# UNITED STATES PATENT AND TRADEMARK OFFICE

APPLICATION NO.	FILING DATE	FIRST NAMED INVENTOR	ATTORNEY DOCKET NO.	CONFIRMATION NO.
10/620,575	07/17/2003	Jang-Jin Yoo	8733.418.10	8871

**Office Action Summary**

## **DETAILED ACTION**

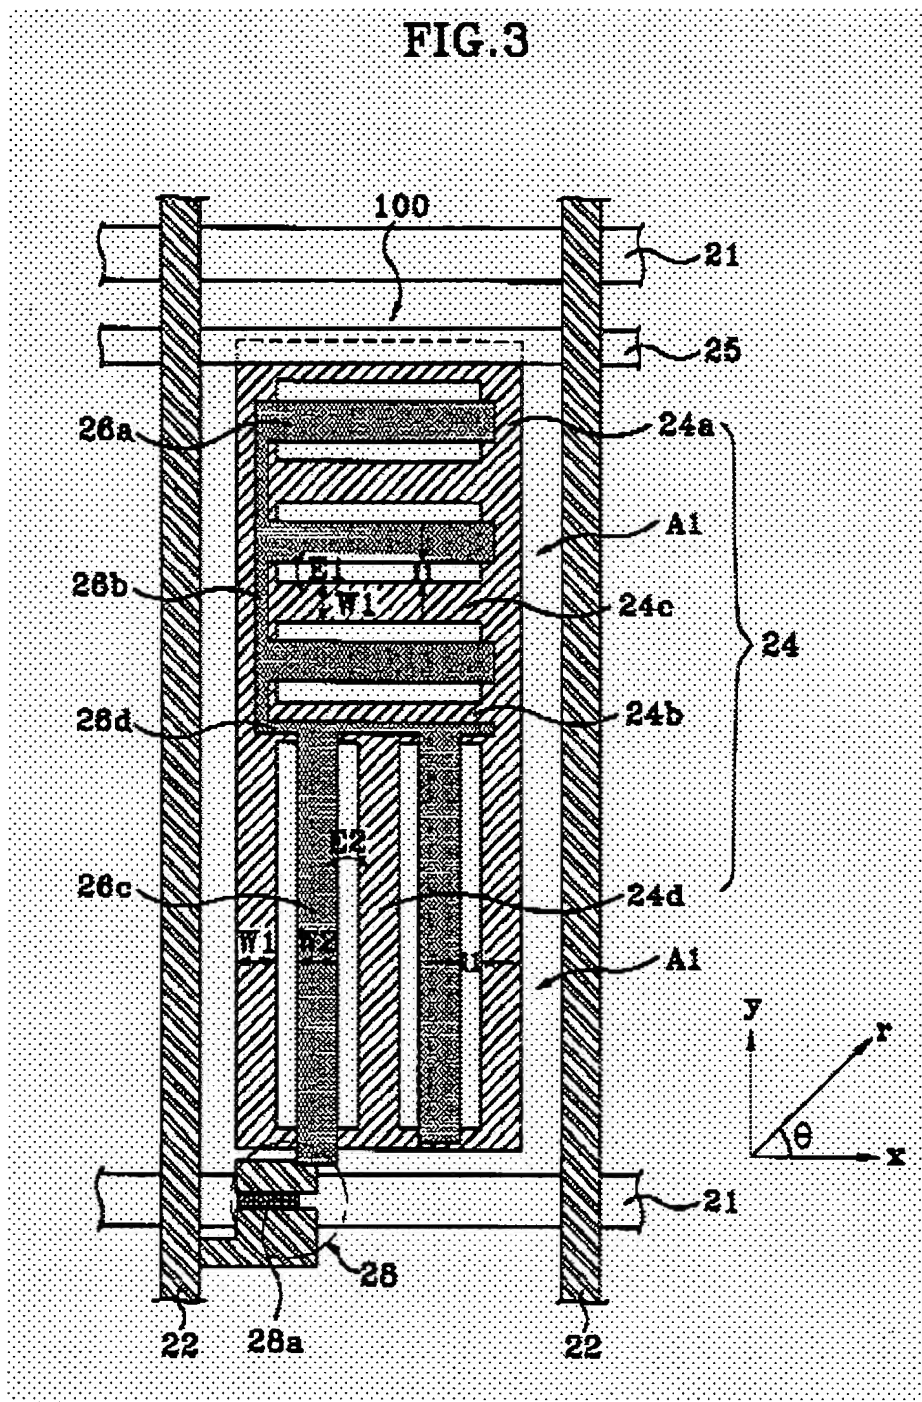
As to claim 18, Lee discloses (Abstract, Title, entire patent and first embodiment) an array substrate for an IPS-LCD device (col. 6, line 35 through col. 9, line 54), comprising:

a substrate; a gate line, 21, on the substrate; a data line, 22, perpendicular to the gate line; a thin film transistor, 28, at a crossing portion between the gate and data lines; a common line, 25, parallel to the gate line; a plurality of common electrodes, 24a, and its

counterpart on the left, extending perpendicular to the common line, the plurality of common electrodes being divided into first and second portions of respective first and second domains [multiple common electrode portions in upper and lower domains]; a plurality of pixel electrodes, 26c and 26b, arranged alternately with the plurality of common electrodes, the plurality of pixel electrodes being divided into first and second portions of the respective first and second domains [multiple pixel electrode portions in upper and lower domains]; an auxiliary common electrode, 24c, perpendicularly contacting each of the common electrodes; and an auxiliary pixel electrode, 26d, perpendicularly contacting each of the pixel electrodes; wherein the auxiliary pixel electrode is spaced apart from the auxiliary common electrode; and the pixel electrodes are on a same layer as said auxiliary pixel electrode, and wherein the plurality of common electrodes have a portion, 24d, that does not continue all the way across the pixel region.

1) It is respectfully pointed out that the present broad claim language allows the presently applied prior art to read on the claims per rejections above. Please note that item 24c contacts each of 24a and its counterpart on the left in Figure 3. Existence of other electrodes is permitted because the claims are in comprising format.

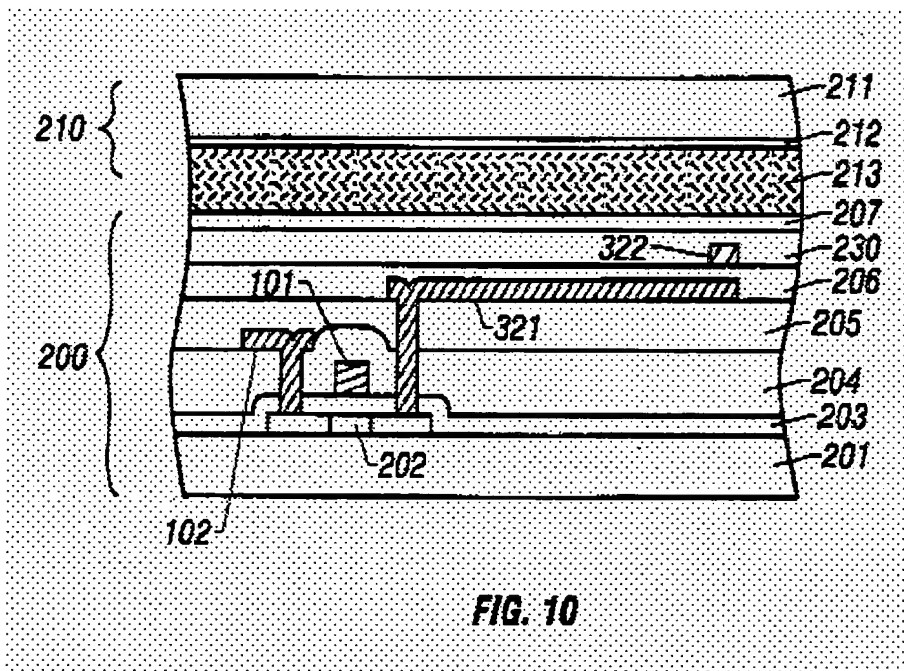
Hirakata teaches in the fourth embodiment (col. 8, line 56 through col. 9, line 34) a dielectric film, 205 (Applicant's first passivation layer), over the gate insulating layer, the data line and thin film transistor; a plurality of pixel electrodes, 321, on the first passivation layer; a second dielectric film, 206 (Applicant's second passivation layer), over the pixel electrodes; a common line, 322, on the second passivation layer to comprise a structure with increased aperture ratio (col. 8, lines 57-59).

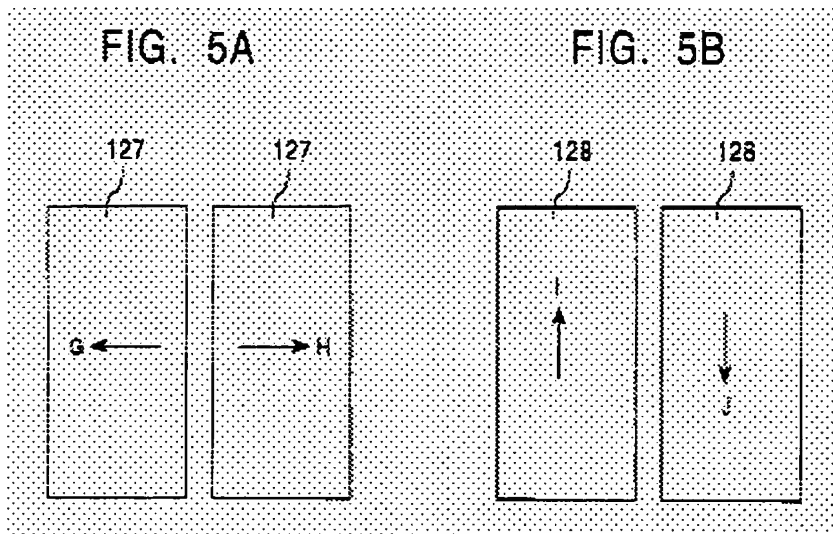
Chen teaches (Abstract, Title, entire patent, Figures 5A and 5B) an alignment layer having first and second rubbing directions, the first and second rubbing directions corresponding to the first and second domains, respectively to enhance image quality by preventing dependence on the viewing angle in the vertical and right-and-left directions with a process as simple as possible [abstract].

Please note that one of the two illustrated arrangements of Chen would be symmetrical about a line parallel to the gate line regardless of whether the gate line runs up and down, or left and right.
